Product Change Notification

Change Notification #: 113195 - 00
Change Title: Intel® Server System R2308GL4GS,
R2308GZ4GC and R2224GZ4GC4
PCN 113195-00, Product Design
Update Resistors and Capacitors
Date of Publication: August 06, 2014

Intel is implementing the following change on the Intel® Server System R2308GL4GS, R2308GZ4GC and R2224GZ4GC4:

Figure 1. Component Locations for the 2U Riser Spare A2UL8RISER

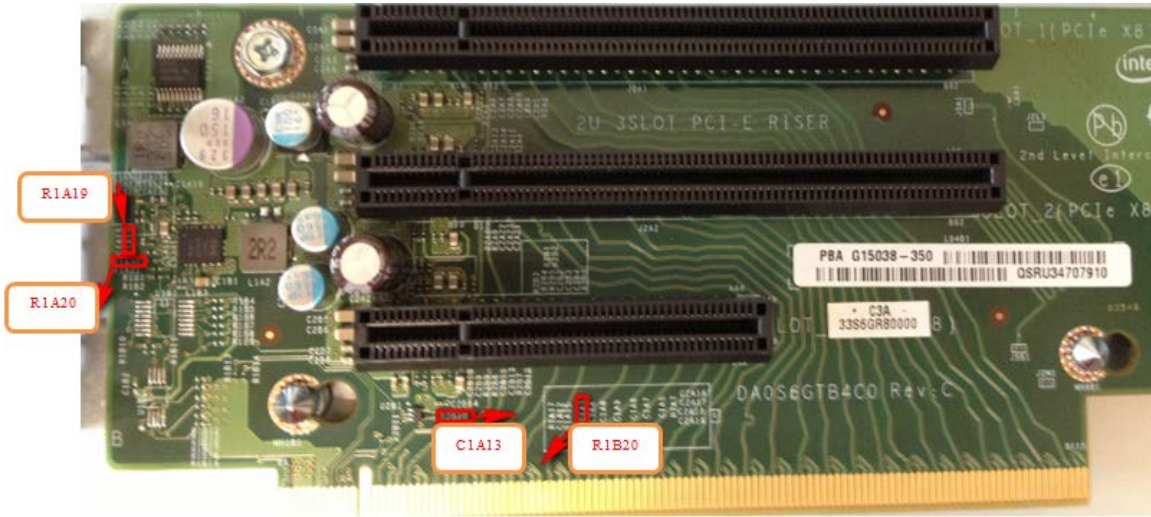
Update the following resistors and capacitor (see Table 1 and Figure 1) on the 2U PCIe Riser Spare A2UL8RISER to make an improvement to support a higher 3.3 Voltage Regulator startup over current. Before this change, the Voltage Regulator on the riser card may not be able to turn on when the total current drawn is more than 5A current. After this change, the Voltage Regulator on the riser card can support more than 10A current.

Component	Location	Pre-change	Post-change
Resistor	R2B10	10.0 kOhm	3.65 kOhm
Resistor	R1A20	0 Ohm	30 Ohm
Resistor	R1A19	40.2 kOhm	20 kOhm
Capacitor	C1A13	10 pF	120 pF
